Agenda Item # 9

BOA-002838-2024

- Height, Density, and Front Landscape Area Variances to allow apartment buildings taller than 45 feet, a density greater than 25 dwelling units per acre, and reduced front landscape area in a B-3, Community Business Suburban District.

APPLICATION NUMBER	6577	DATE	March 4, 2024
APPLICANT	633 Development, LLC		
REQUEST	Height, Density, and Front Landscape Area Variances

SITE PLAN

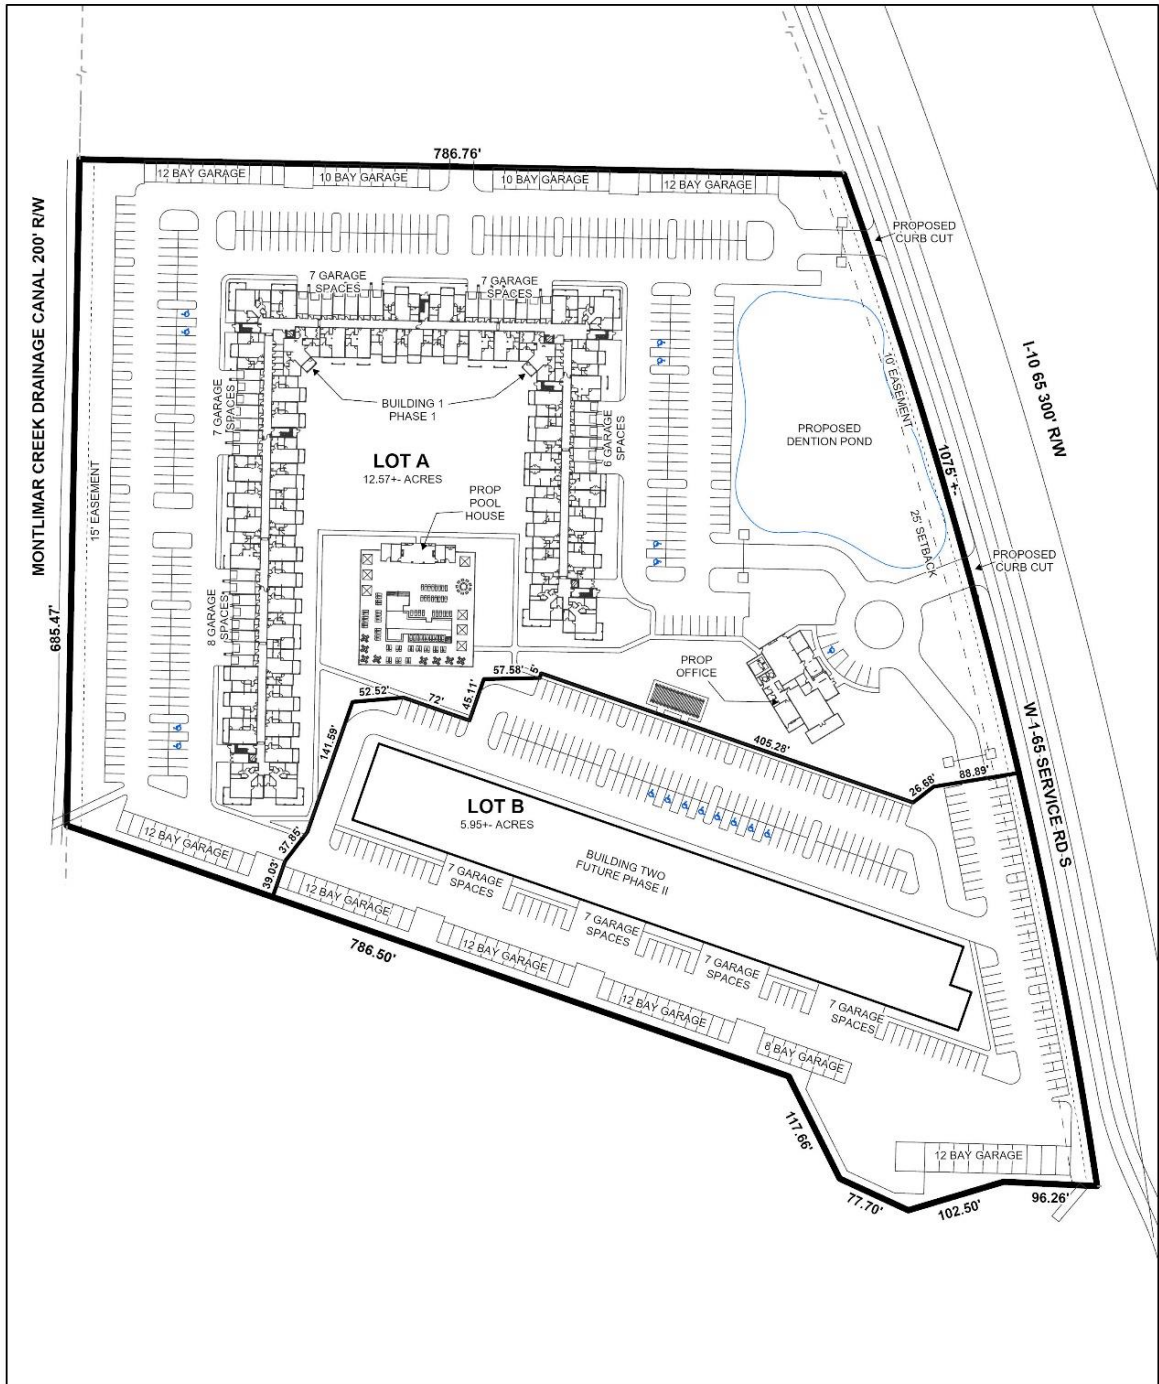
The site plan illustrates two (2) phases; Phase 1 / Building 1 on Lot A and Phase 2 / Building 2 on Lot B. The UDC (64-2-14.E.) allows a maximum density of 25 units per acre in a B-3 district. Accordingly, Lot A is allowed a maximum of 314 units, 254 are proposed; and Lot B is allowed 148 units, 210 are proposed. The overall site (Lots A and B combined) are limited to 463 units, so for the overall the site the applicant is requesting one (1) additional unit. The applicant states 464 units area allowed for the overall site; however this difference is likely attributable to rounding.

The site plan illustrates additional site improvements, including an office building, pool house, pool, multiple garages, and parking. A table on the site plan indicates 761 total parking spaces will be provided for both phases, which exceeds the 696 spaces required for a 464-unit apartment complex, per Table 64-3-12.1 in Article 3. Besides the variances requested, development of the site will need to fully comply with all other requirements of the UDC.
